Addendum No. 1 to Contract Documents

Project	Water District No. 2 Distribution System Replacement	Project No.	8616265
Owner	Town of North Castle, New York	Federal Project No.	--
Contract No.	1 - General	Date	June 3, 2014

Addendum No. 1 to Contract Documents
Water District No. 2 Distribution System Replacement
Town of North Castle, NY
Contract No. 1-General
GHD Project No. 8616265
June 3, 2014

Client	TOWN OF NORTH CASTLE, NEW YORK		
Project	WD NO. 2 - DISTRIBUTION SYSTEM REPLACEMENT		
Title	DETAILS		
Contract No.	1		
Original Size	Ansi D		
Drawing No:	86-16265-C046		
Rev:	1

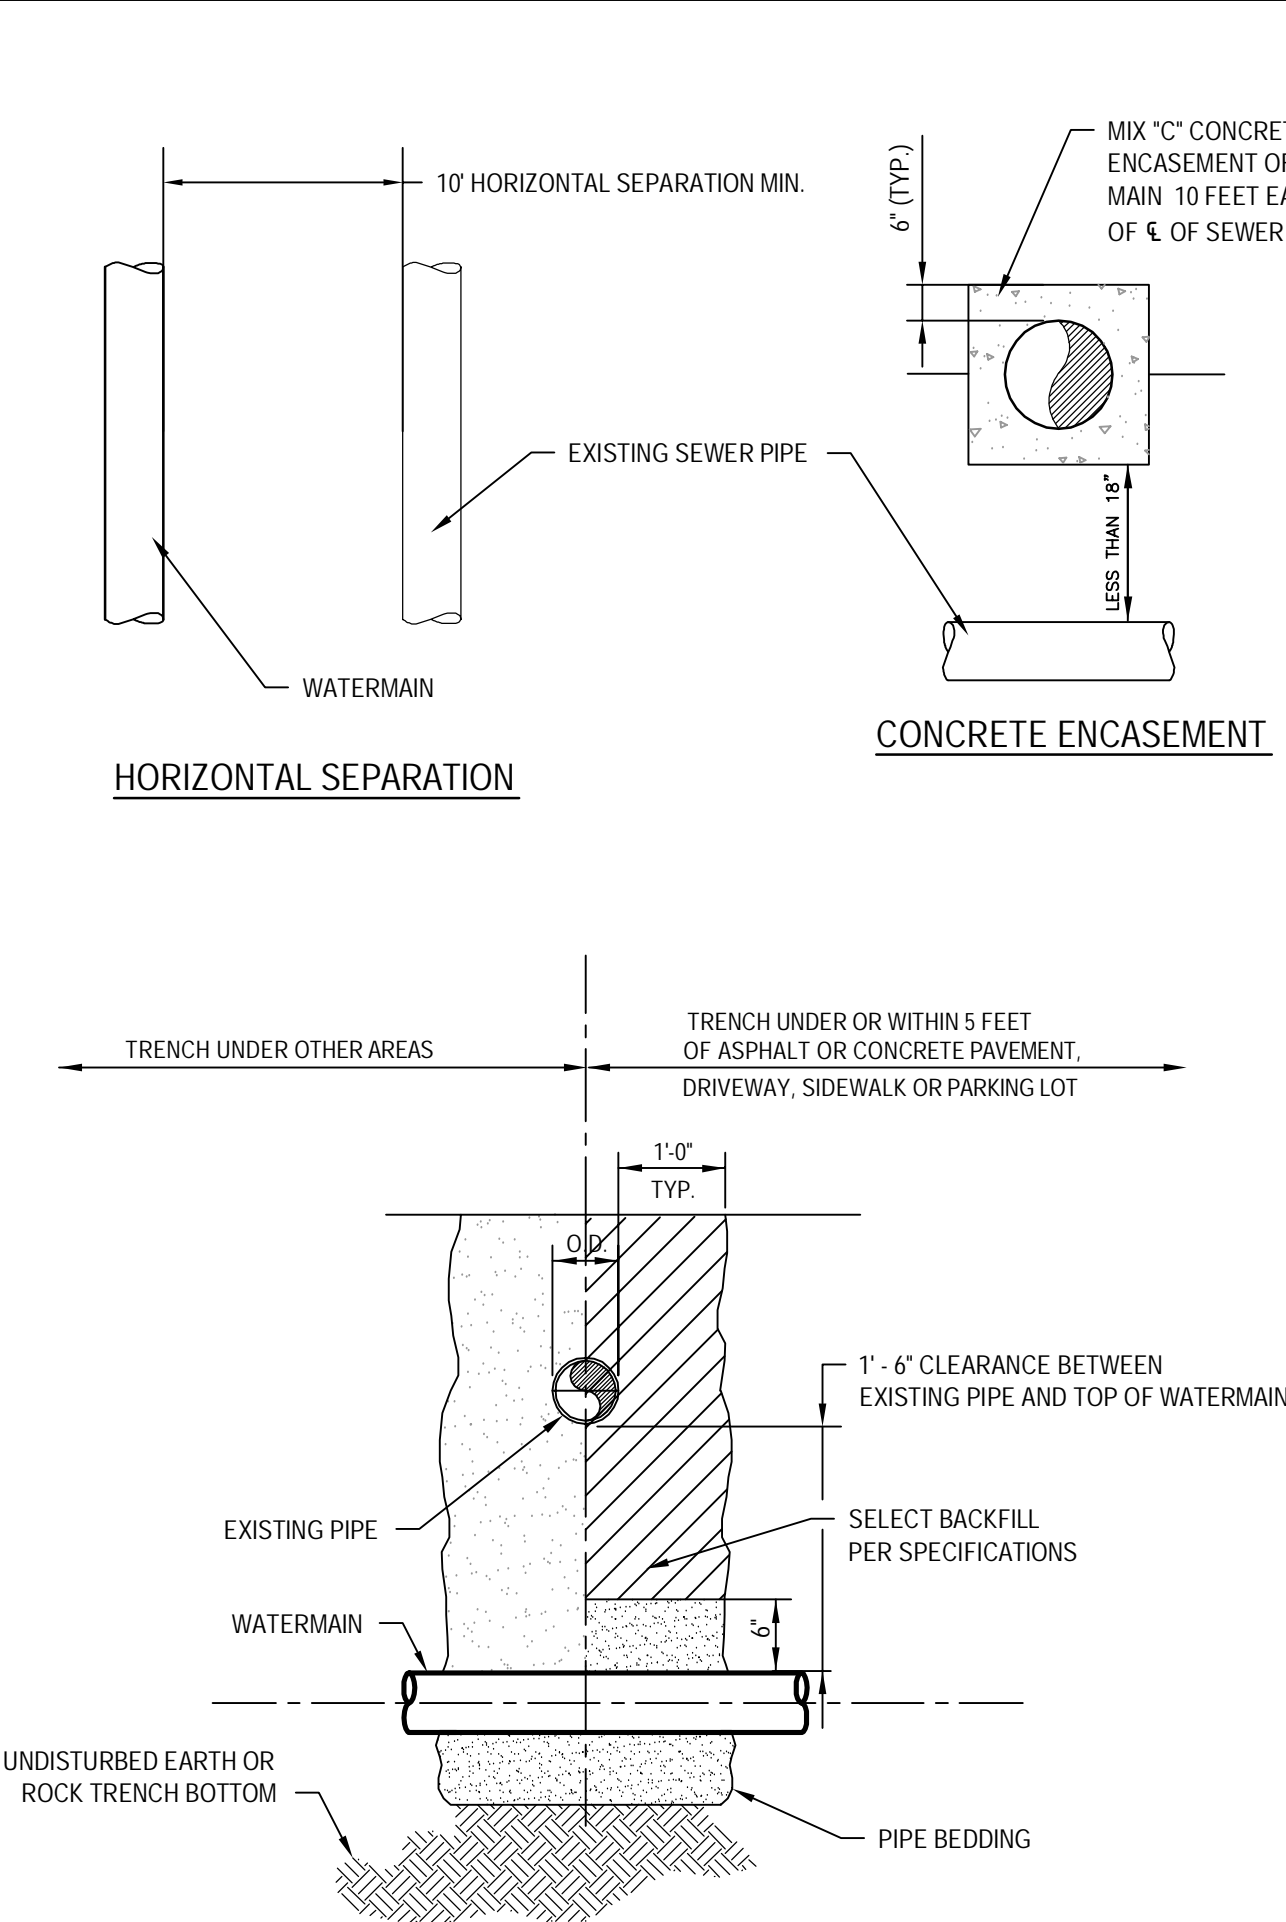
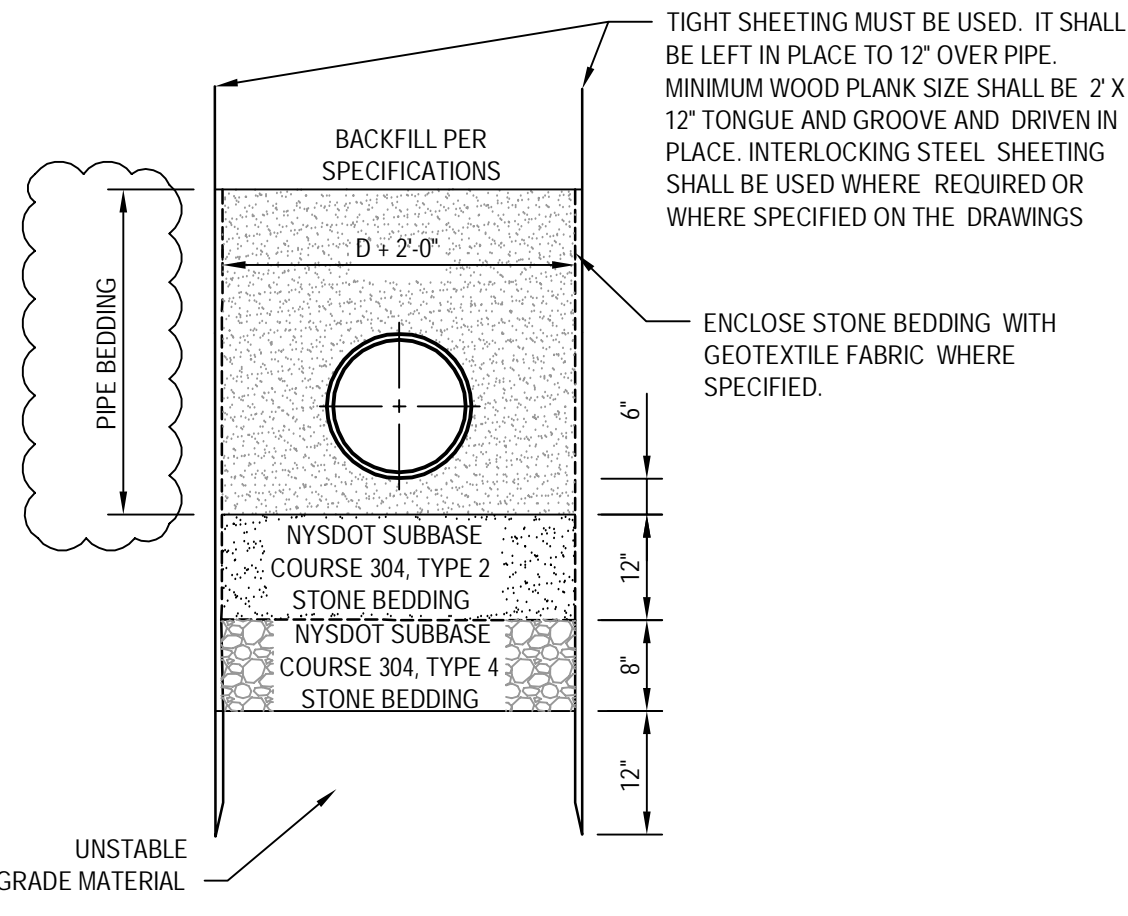
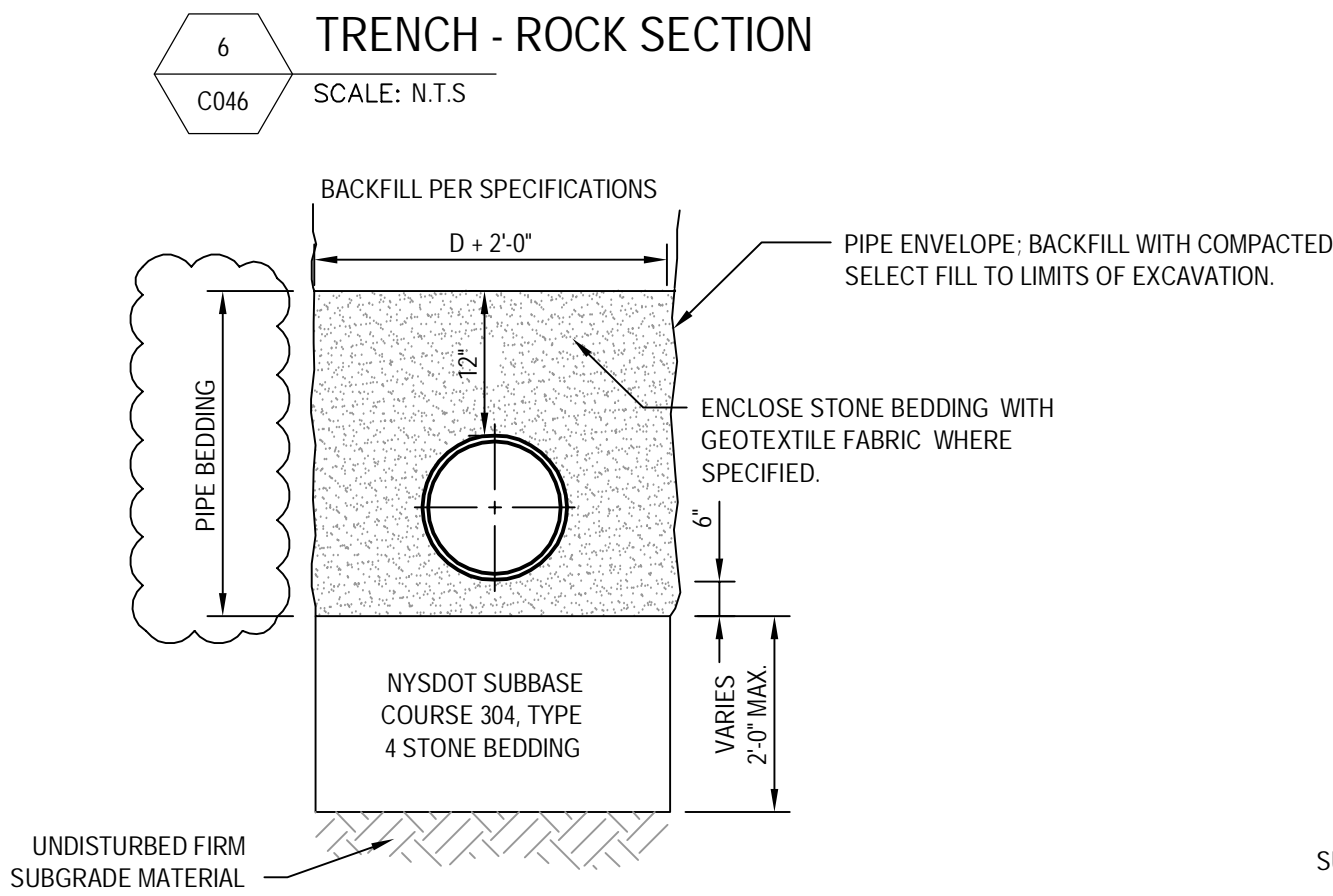
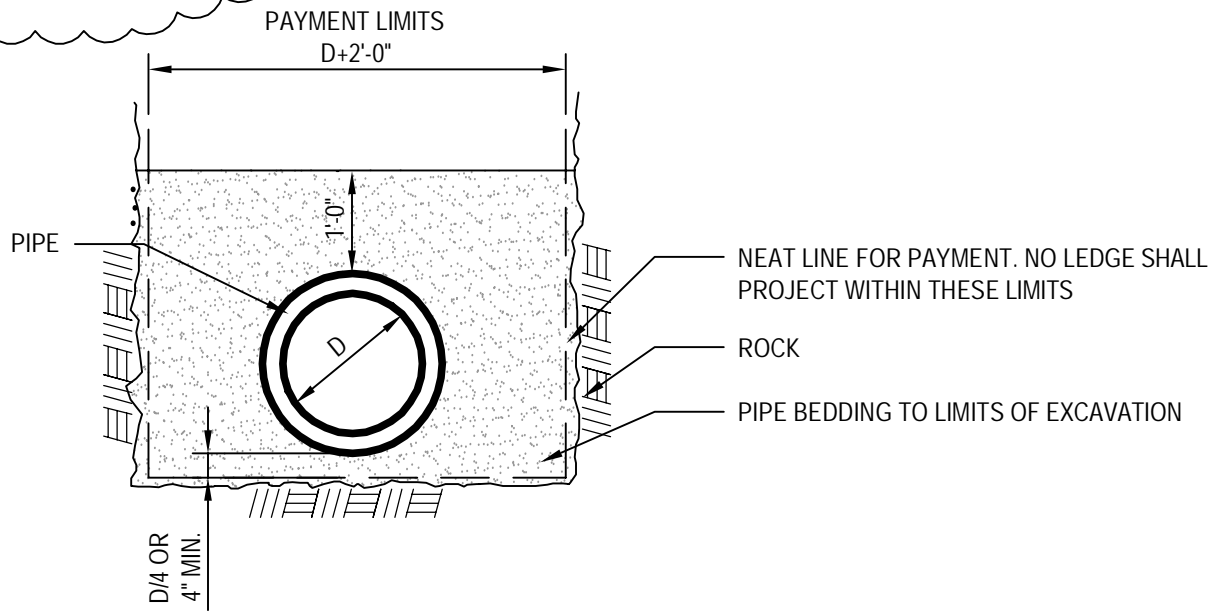
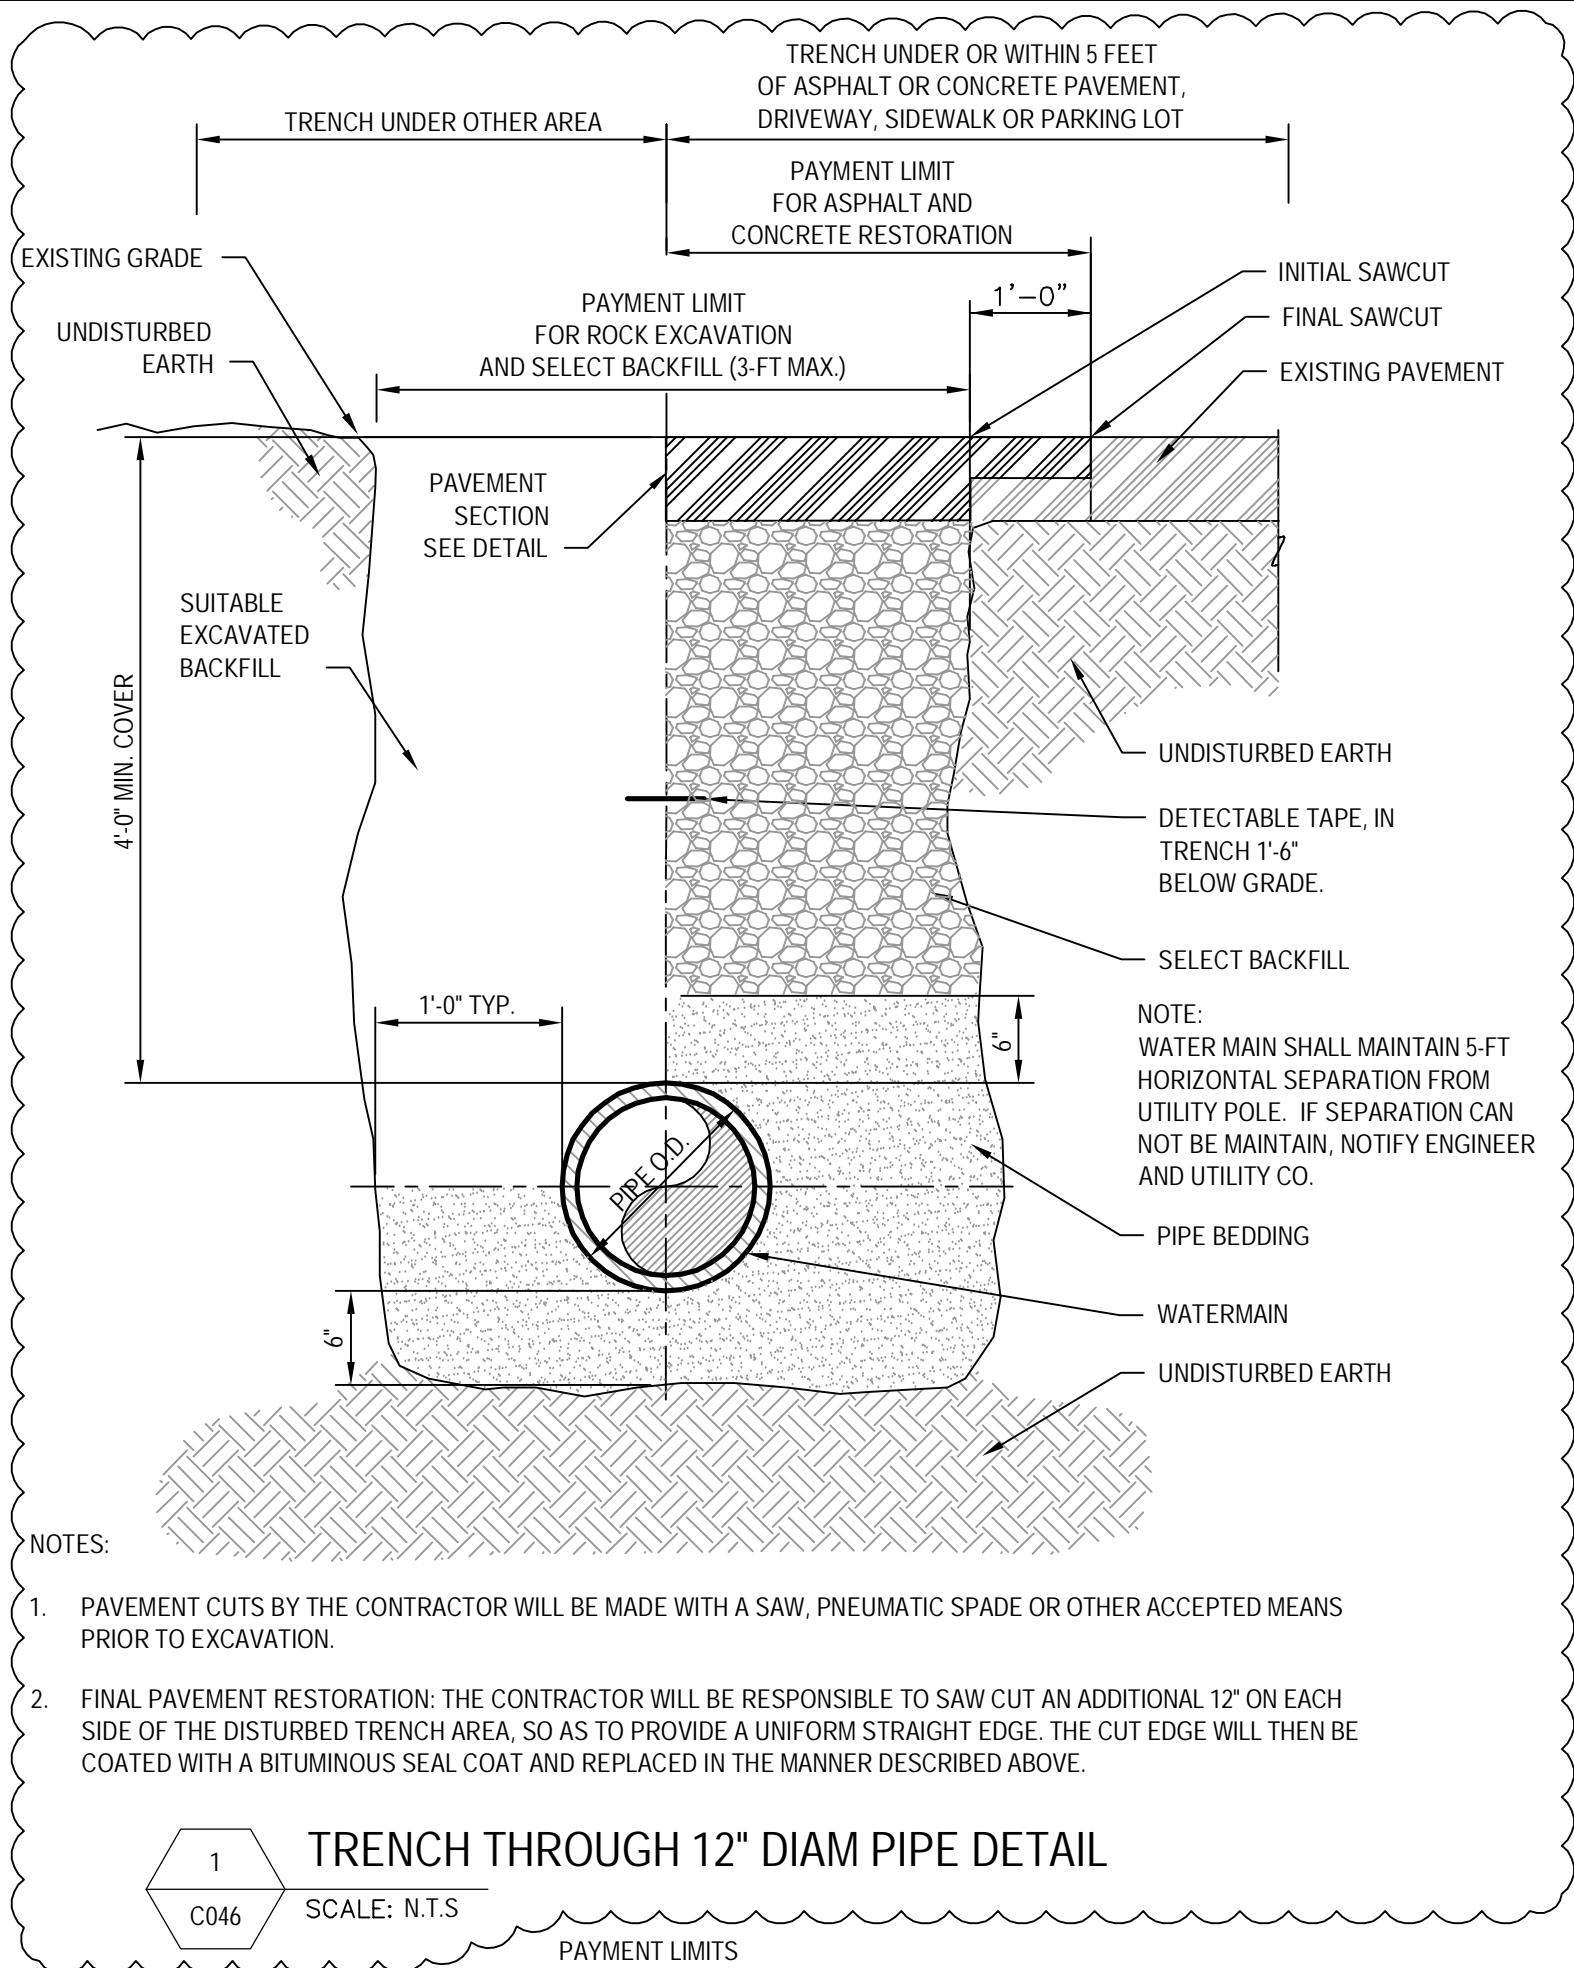
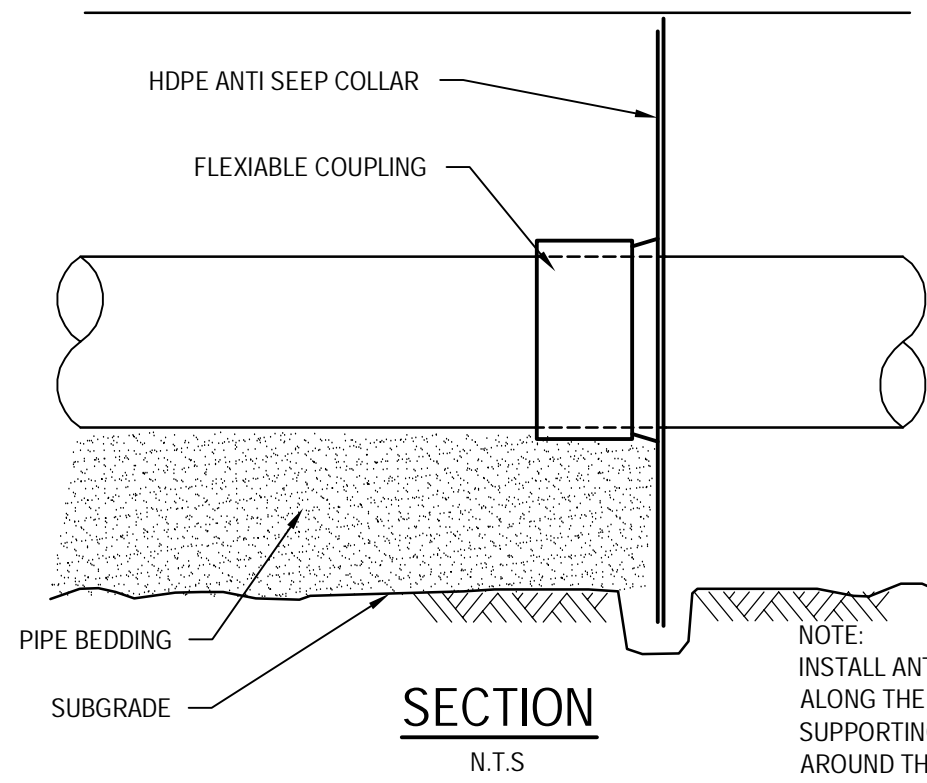
REMOVE Drawing C046 and **REPLACE** with Drawing C046 (Attachment No. 8).
